Gallien Technology

To connect a 1001RB MARK II power amp board using a 1001RB MARK I transformer.

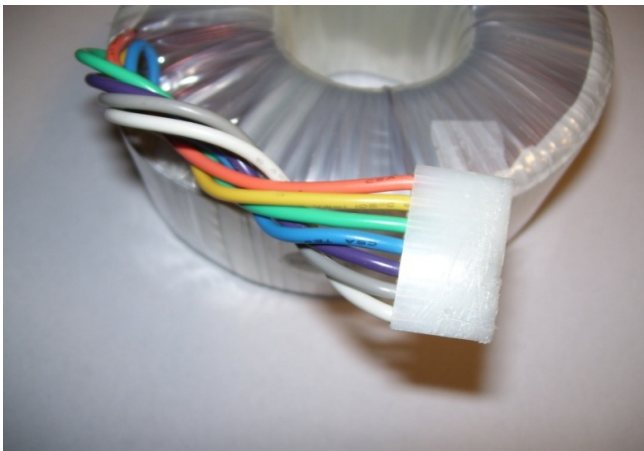
Physical connections are different for both boards.

Black, white and brown wires remain the same as marked on board as well as the - green wire(ground), red wire must be connected to J15 as shown in pic #3.
